Private Fuel Storage, L.L.C.

February 22, 2000

EIS COMMITMENT RESOLUTION LETTER #6
DOCKET NO. 72-22 / TAC NO. L22462
PRIVATE FUEL STORAGE FACILITY
PRIVATE FUEL STORAGE L.L.C.

Figure 19
Photo Location Map - Rail Siding Area

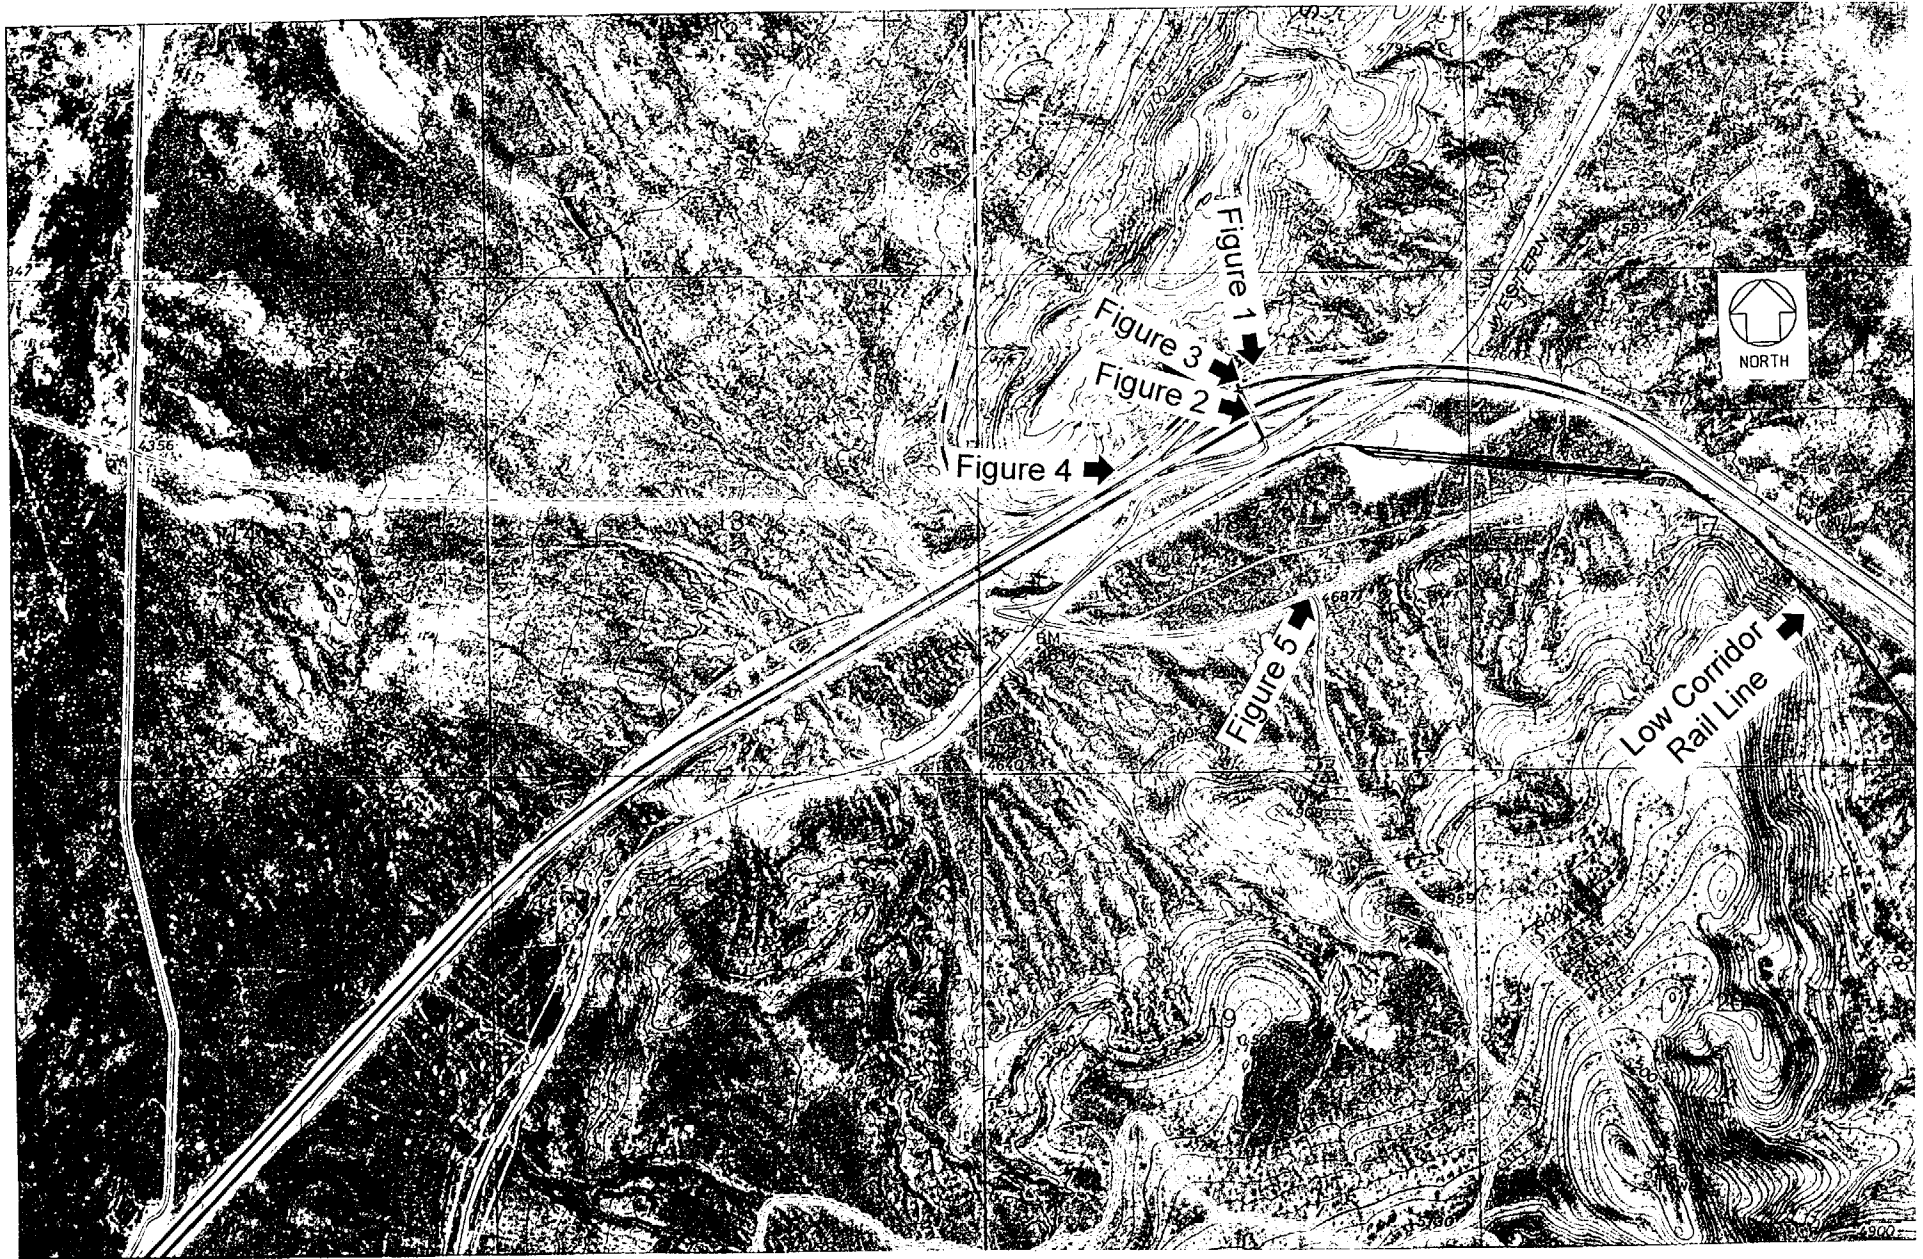
5. PFS should provide a map that shows the location where the photographs included in ER Chapter 4, Appendix 4A were taken. Each location on the map should include an arrow that shows the direction of the view presented.

RESPONSE – Figures 19, 20, and 21 are included as Attachment 3. These Figures show the location where the photographs included in ER Chapter 4, Appendix 4A were taken and include an arrow that shows the direction of the view presented.
